Letter of Objection to the development at Former Tower
Car Sales, Tower Close, East Grinstead, West Sussex
(now known as Whittaker House, 1 Leppard Walk) and
retrospective application DM/26/1449

This application is ostensibly the same as the original application DM/26/0432; due to this I have included my original complaint letter from that application as Appendix A to this letter – I would like my original letter of complaint for DM/20/0432 to be considered in its entirety regarding this application.

Appendix A – original letter of objection for **DM/26/0432**

Letter of Objection to the development at Former Tower
Car Sales, Tower Close, East Grinstead, West Sussex
(now known as Whittaker House, 1 Leppard Walk) and
retrospective application DM/26/0432

The promotional material (same images as submitted plans); the current front of the building;

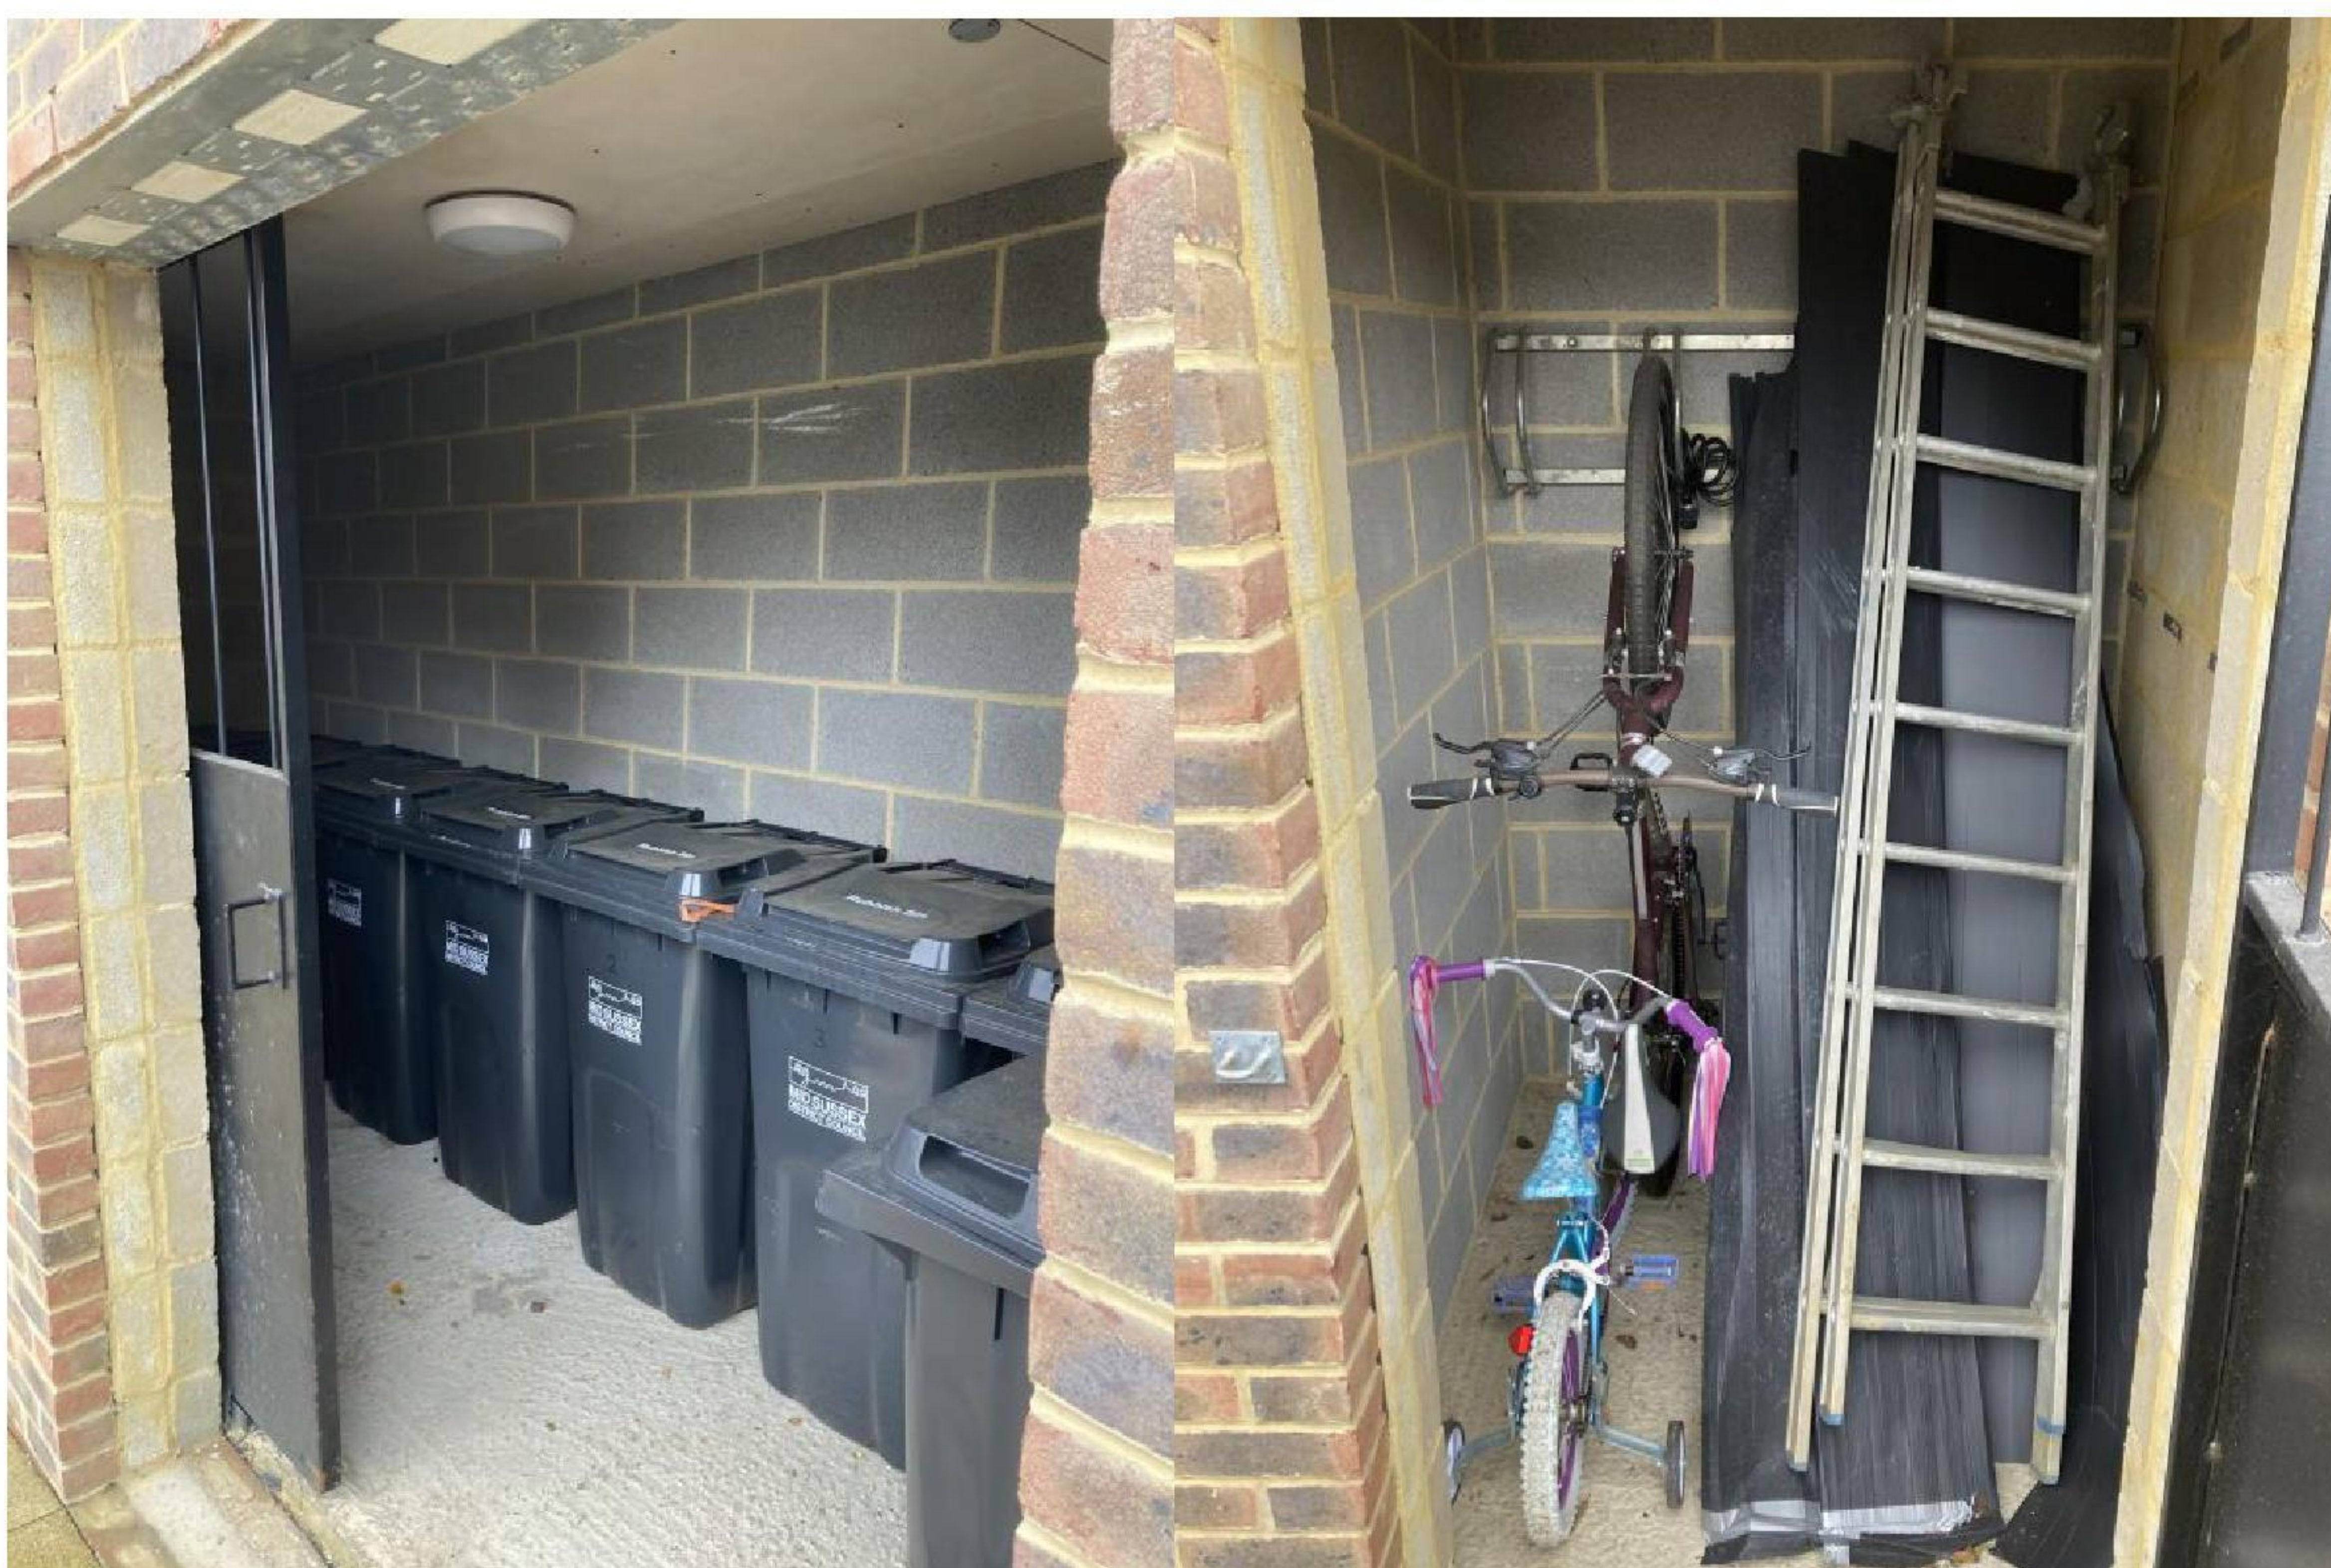
Planning permission was granted with acknowledgement of this, and noting that resident would not have to enter through the undercroft:

The entrance is now our 'dedicated bin and bike storage'. These are so unsuitable for the purpose as to be functionally useless. They remain unfinished, with unfinished brickwork (and bin storage) now forming part of the view for our neighbours. The bin storage area holds 8 bins, with the 9th squeezed in. Our recycling bins now live in the undercroft, as there is no 'dedicated bin storage'. The 'dedicated bike storage for 10 bikes' is honestly my favourite part of the development:

Dedicated bin storage; Dedicated secure storage for 10 bikes

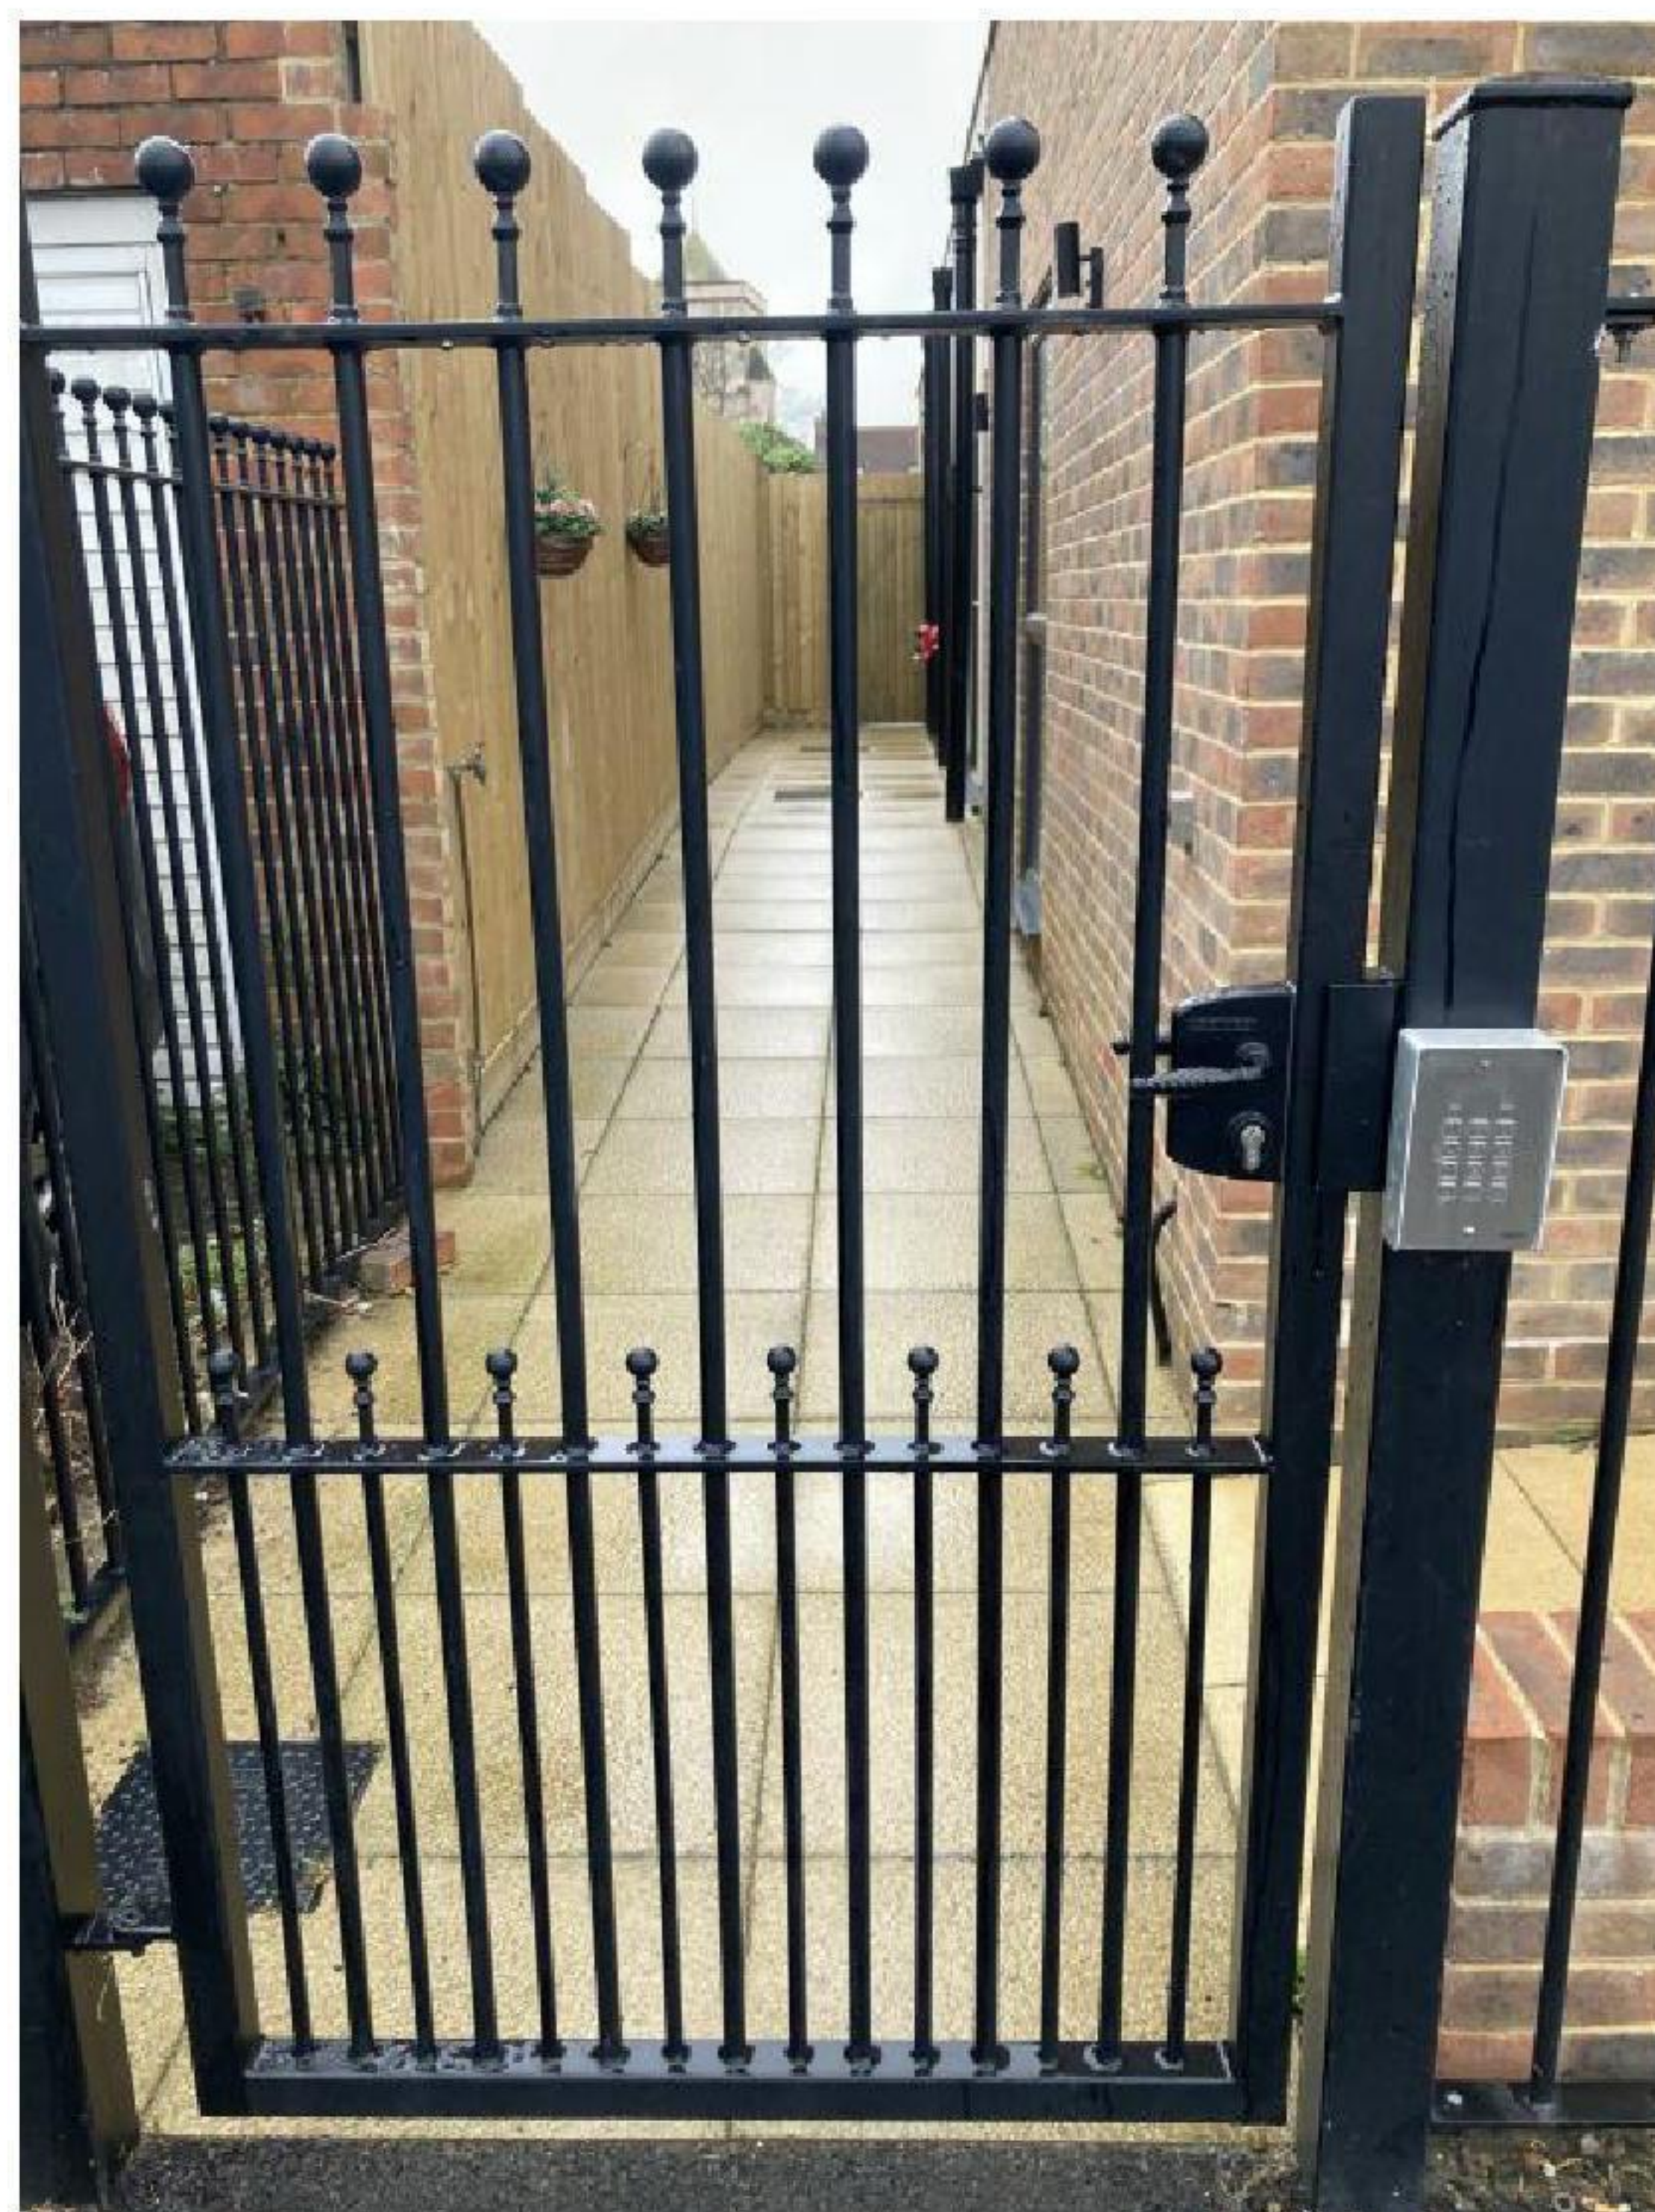
It would be funny if the property hadn't been marketed and sold as having dedicated secure bike storage, if said storage wasn't also mentioned when granting planning permission, and if several of the current freeholders hadn't purchased their property with this specific feature in mind.
